Browns Ferry Nuclear Plant, Units 1, 2, and 3  
Renewed Facility Operating License Nos. DPR-33, DPR-52, and DPR-68  
NRC Docket Nos. 50-259, 50-260, and 50-296

**Subject: Browns Ferry Nuclear Plant, Units 1, 2 and 3, License Amendment Request to Revise Emergency Plan Staff Augmentation Times (TS-515)**

License Amendment Request to Revise Emergency Plan  
Staff Augmentation Times (TS-515)

**Figure A-1  
TSC EMERGENCY ORGANIZATION  
(including minimum staffing and augmentation)**

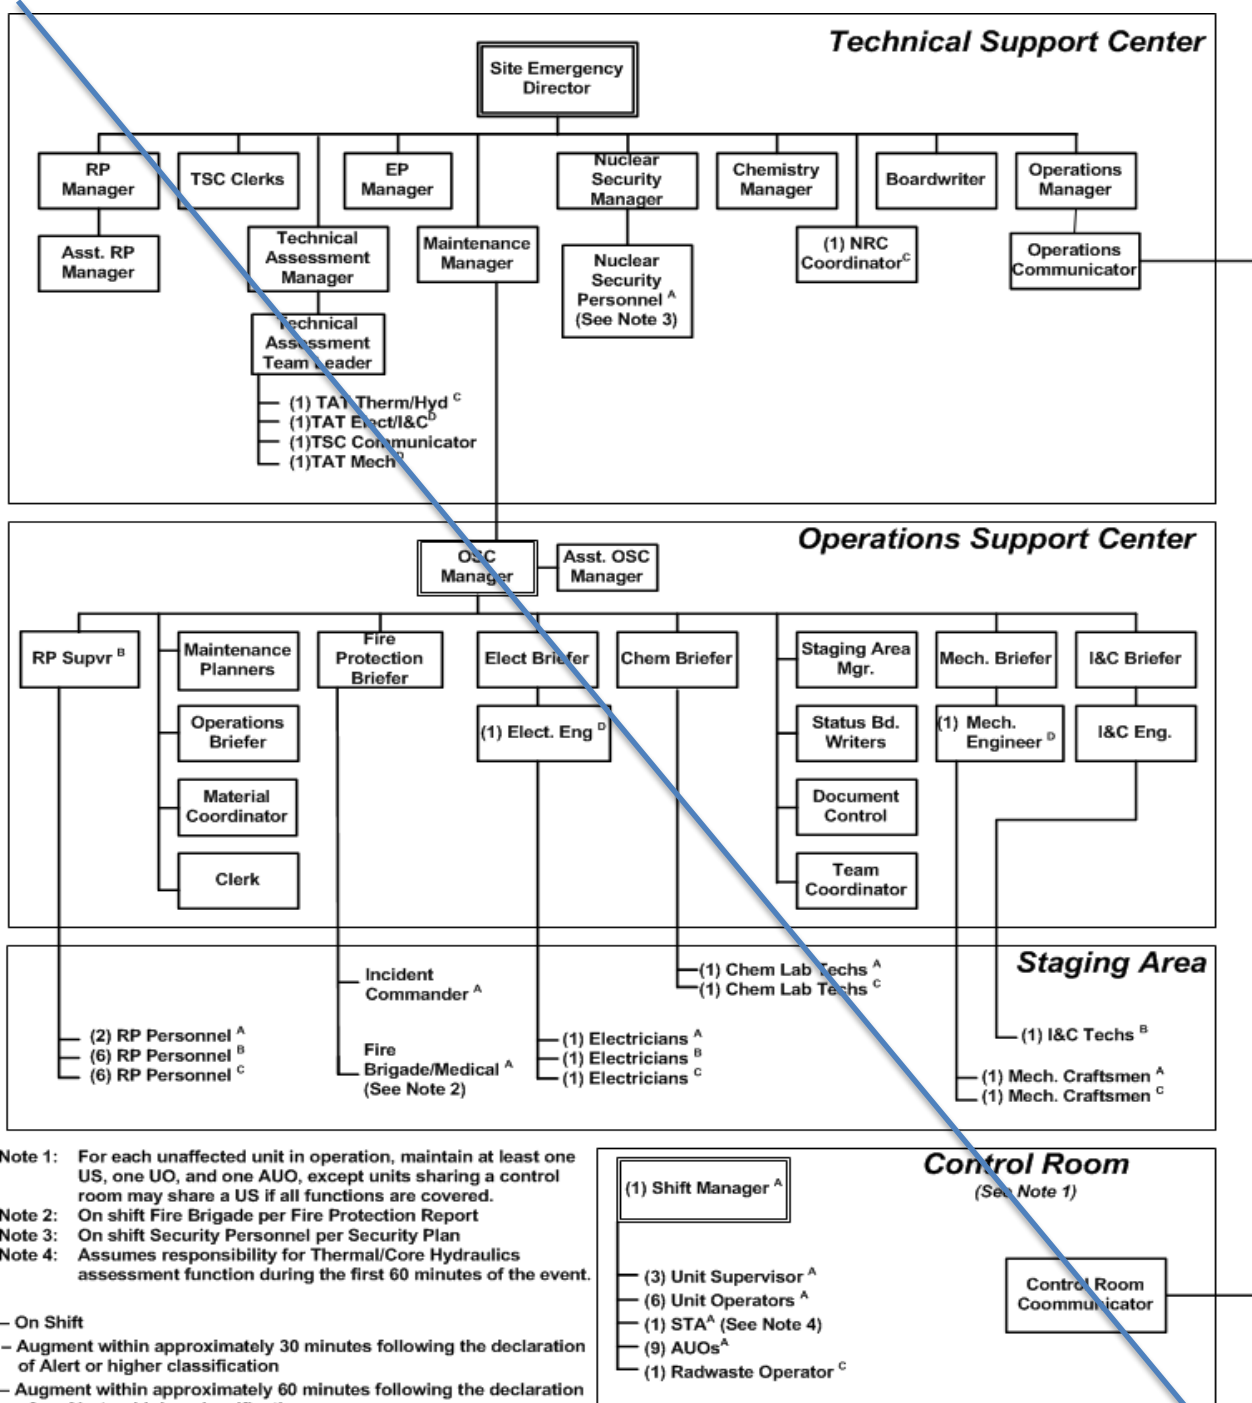
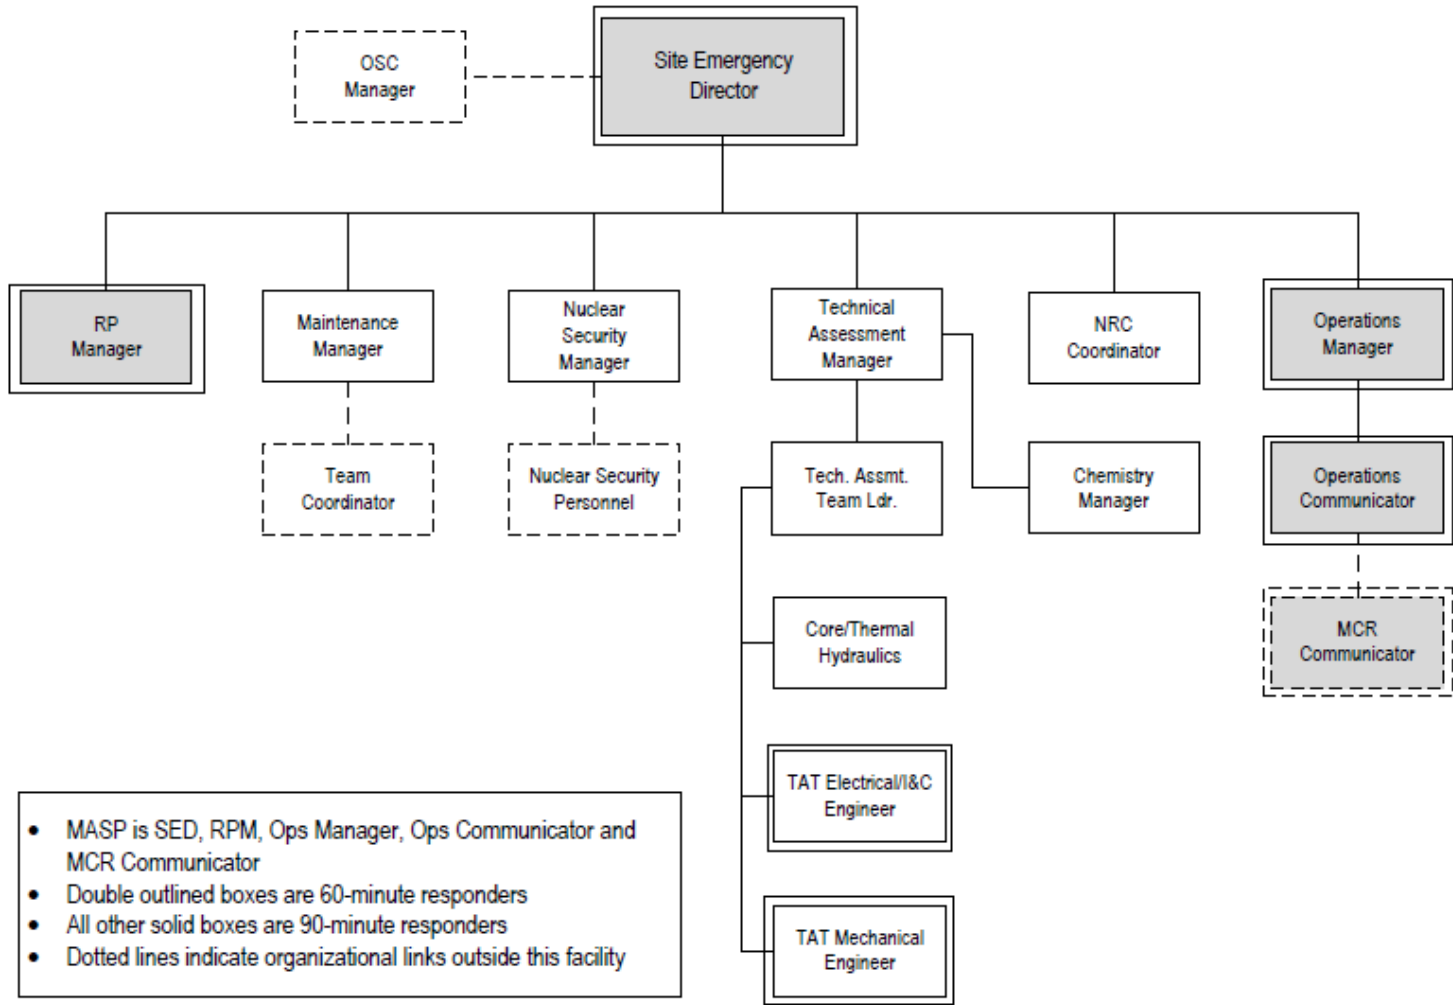
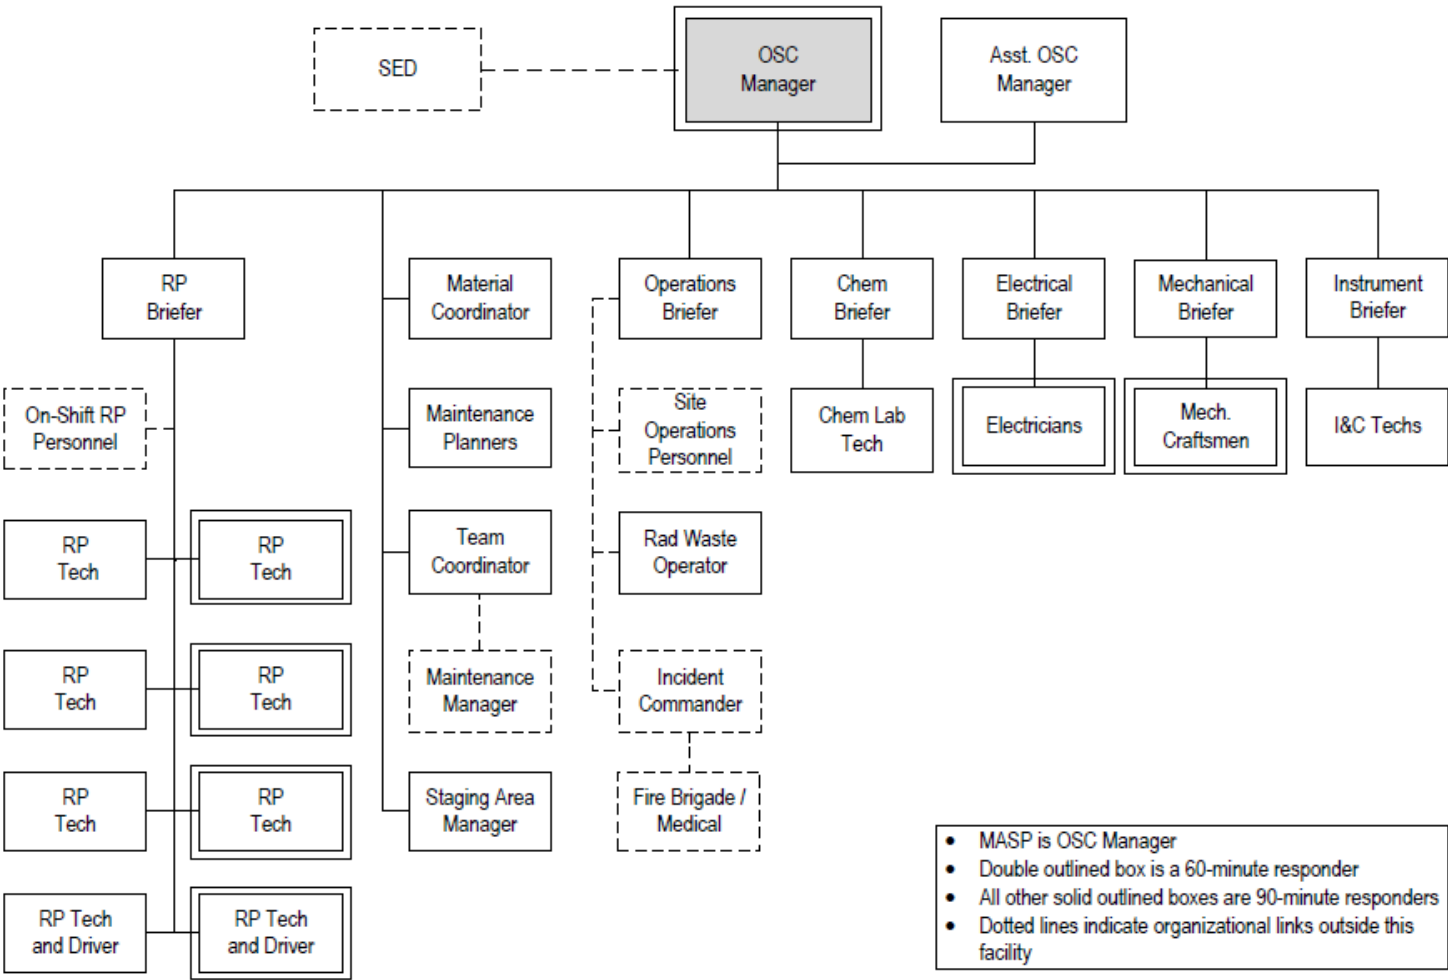
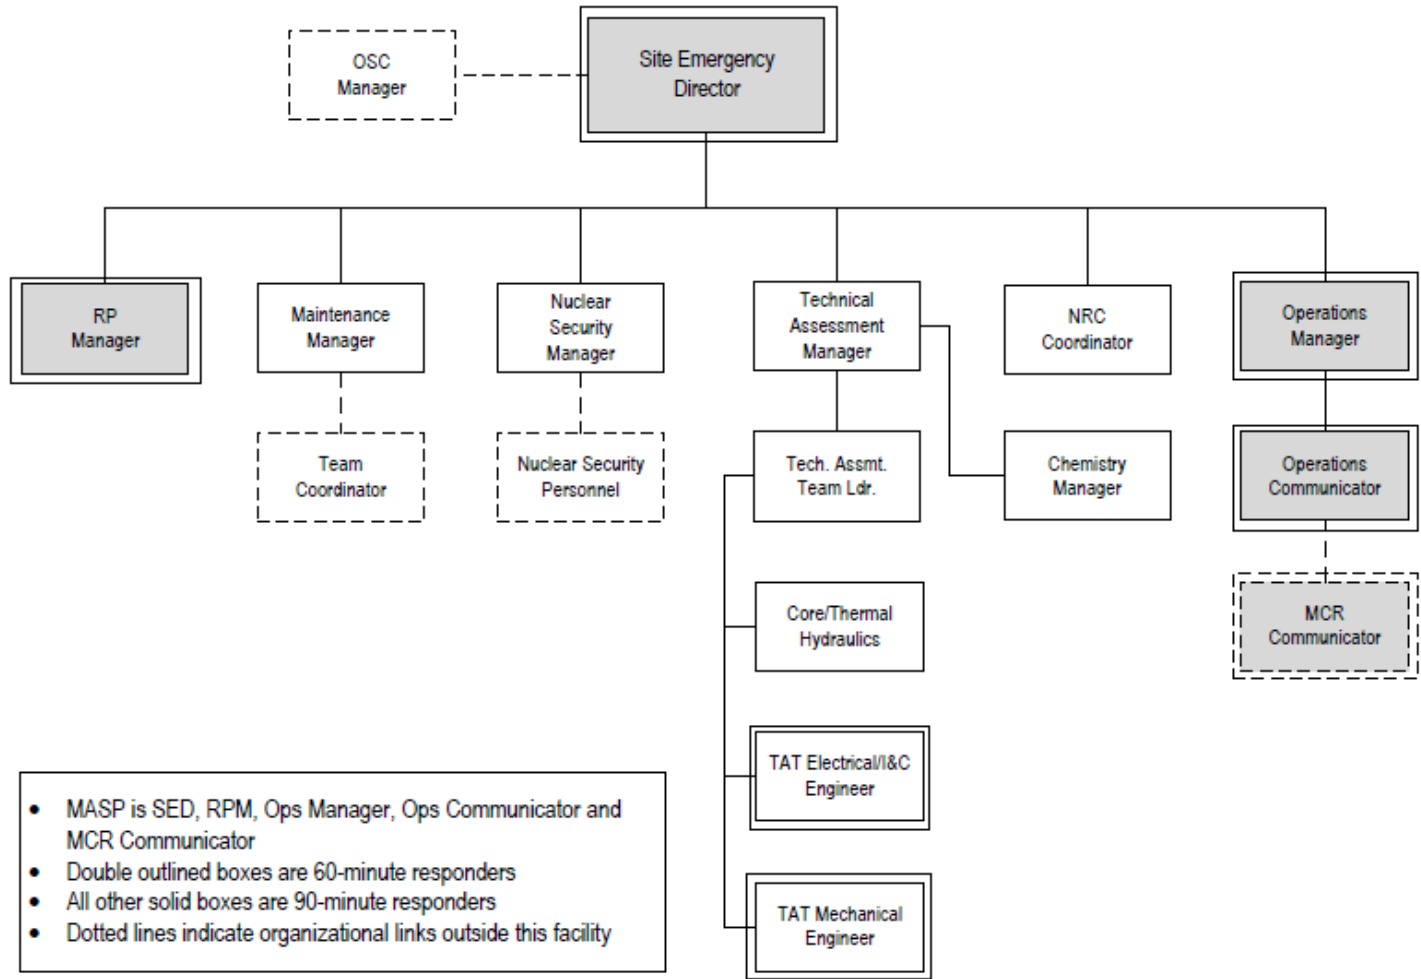
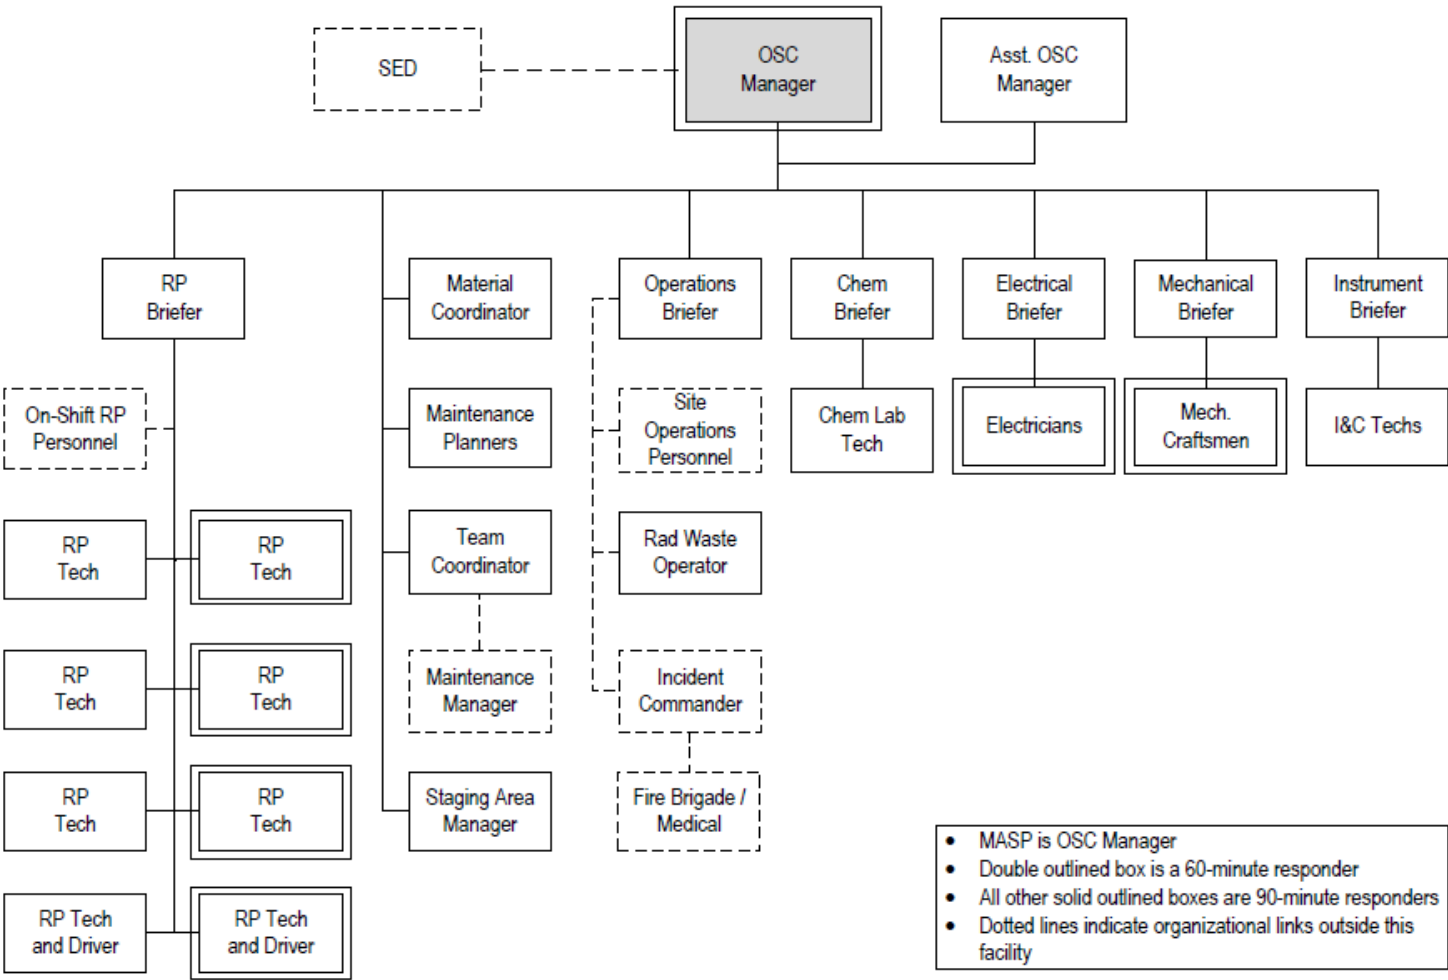
- m. Appendix A, Section 3.18, "Emergency Preparedness Manager," deleted section to align with proposed changes to ERO.
- n. Appendix A, Figure A-1, "Site Emergency Organization," revised to split TSC and OSC organizational structures into separate pages, added indications for minimum staffing positions in each facility.

The proposed revision to BFN Emergency Plan Appendix A, Figure A-1, identifies MASP in the TSC and OSC which support activation of the facilities within 60 minutes of an Alert or higher classification as:

The response times for positions in the TSC and OSC, as noted in revised Figure A-1, are extended from 30 minutes to 60 minutes for MASP positions and from 60 minutes to 90 minutes for the remaining positions.

**FIGURE A-2  
MINIMUM SHIFT RESPONSE PERSONNEL**

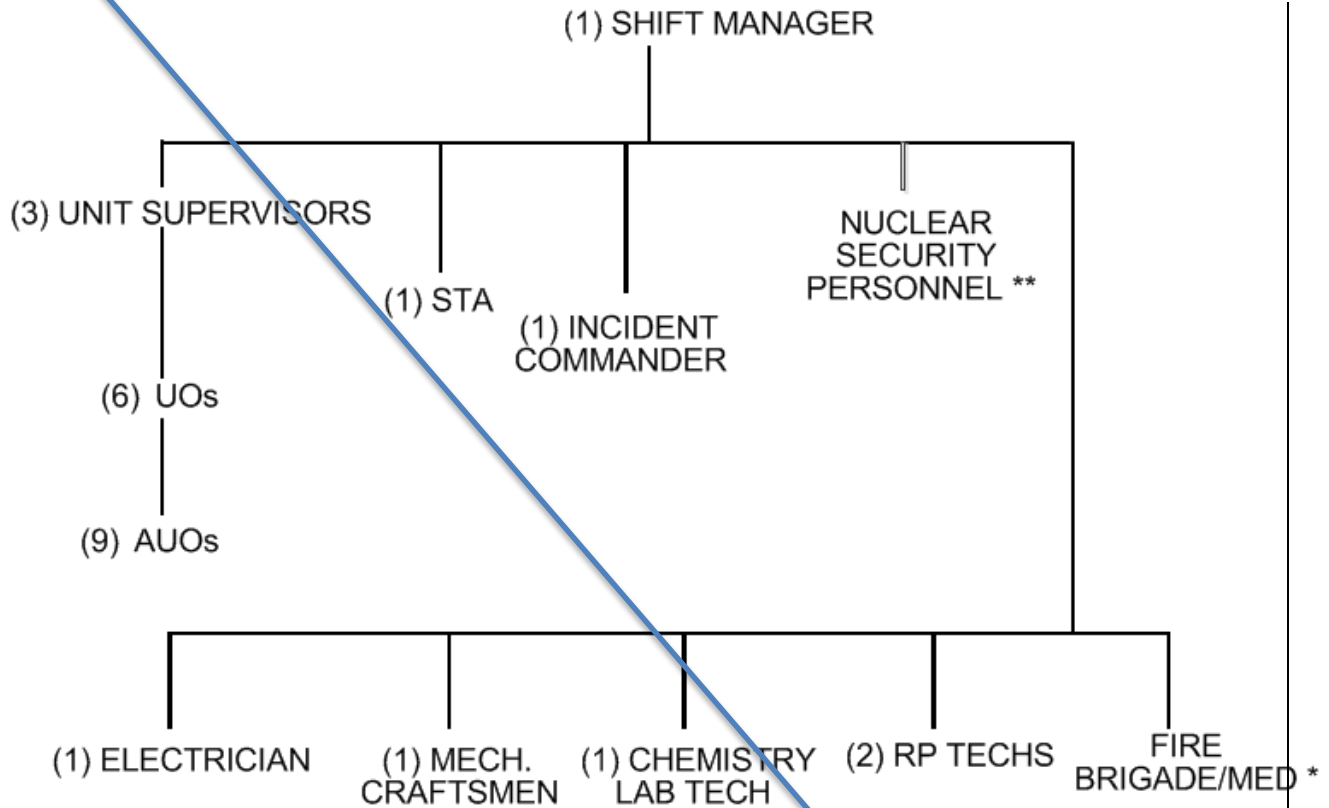
- o. Appendix A, Figure A-2, "Minimum Shift Response Personnel," revised to include table utilizing format noted in NUREG-0654, Rev 1, Table B-1 to indicate on-shift, 60-minute and 90-minute response positions. Figure A-2 title was renamed, "Minimum Emergency Response Staffing"

- c. In the proposed Emergency Plan, Figure A-2 has been reformatted to more closely align with NUREG-0654, Revision 1, Table B-1. Additionally, Figure A-2 includes augmented response positions that are credited with command and control functions as defined in the BFN Emergency Plan. The total number of on-shift staff continues to exceed NUREG-0654 Revision 1, Table B-1 values. As stated in Section 3.1, an on-shift staffing analysis determined that the proposed changes did not result in conflicting duties for on-shift staff. Therefore, the proposed increase in augmentation times will not detract from the capability of on-shift personnel to support plant operations or the assessment of operational aspects major task.
